LASTI ETM

Coating characterization

CALTECH's Report
LMA Meeting, Lyon
October 19th, 2007

ABSORPTION

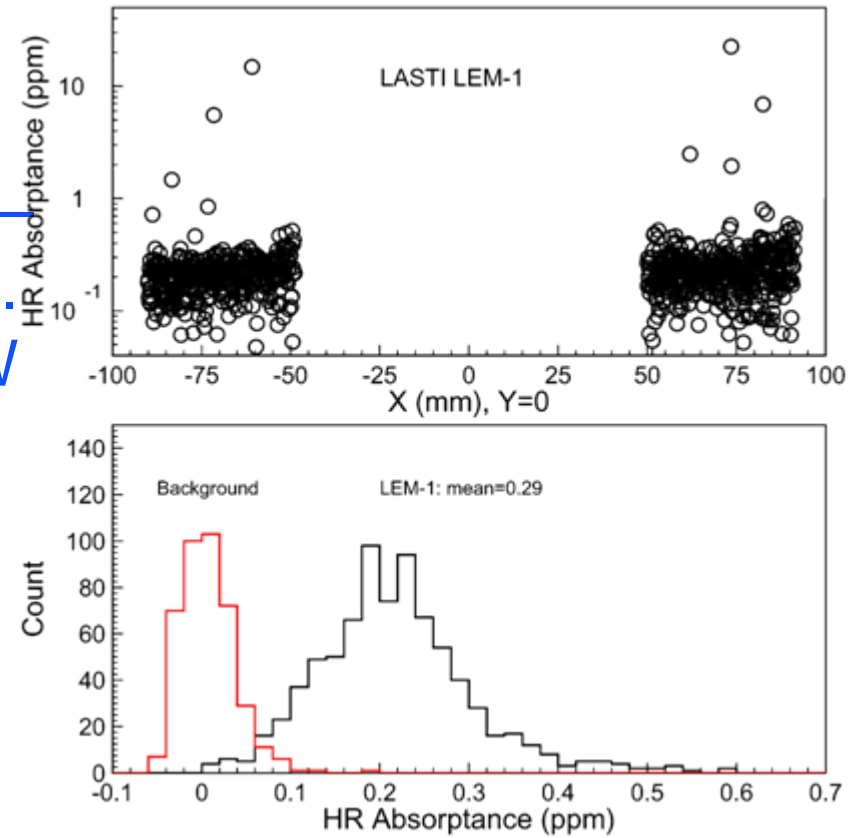
Measured absorption: 0.3 ± 0.1 ppm.

TRANSMISSION

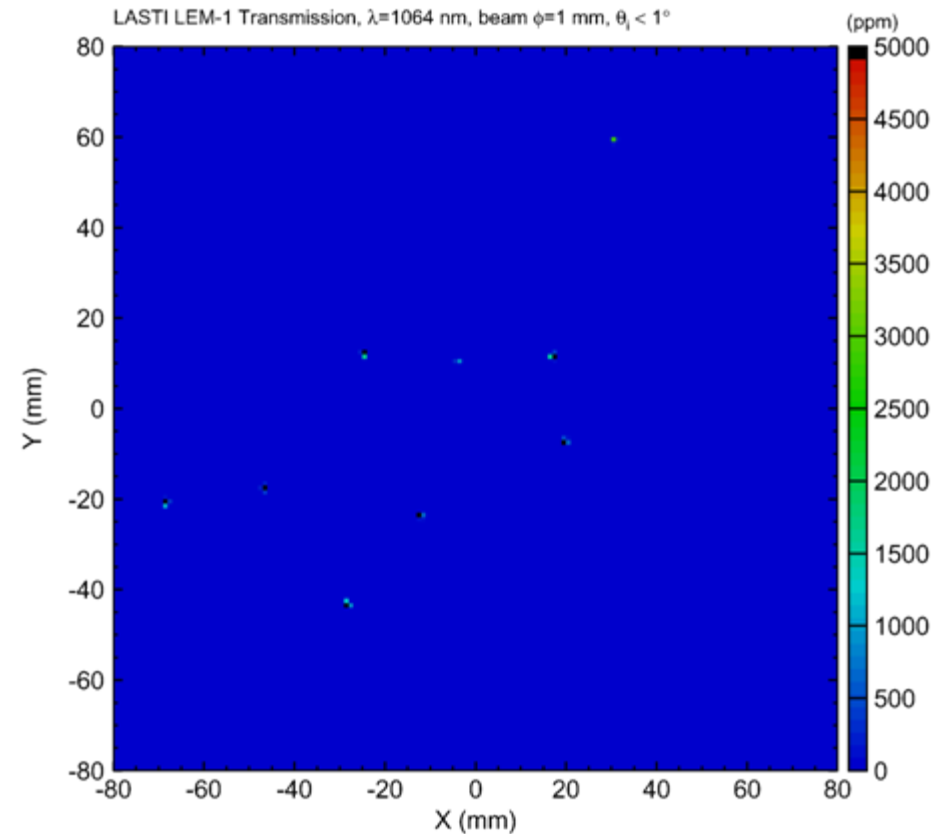
Transmission showed good uniformity

Found 9 high transmission points (bubbles)

The contribution of the points is about 1/3 of the overall average of transmission and is non-negligible.

- The coating satisfied the LASTI coating requirements
- The absorption and scatter results were consistent with the measurements from LMA
- AR uniformity needs to be understood
- High transmission points (bubbles) need to be investigated

AR REFLECTION

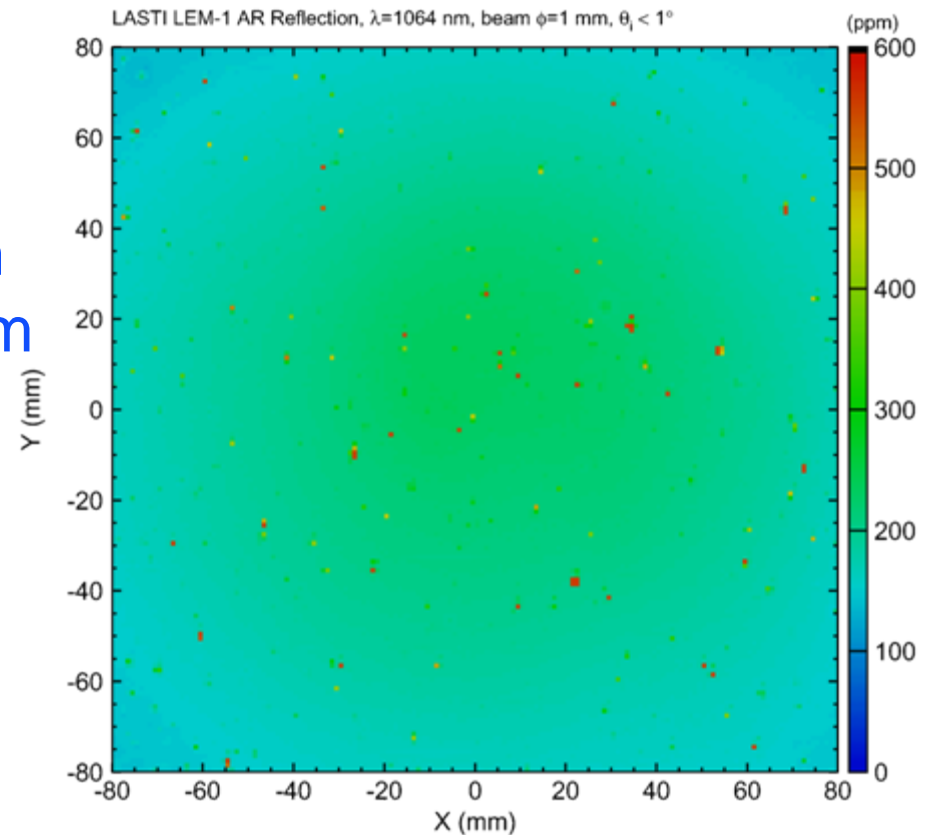
The reflection of the AR coating was measured with a 1mm dia. collimated beam at the central part of 160 mm × 160 mm. The map shows 230 ppm at center, 160 ppm at edge and an average of 180 ppm.
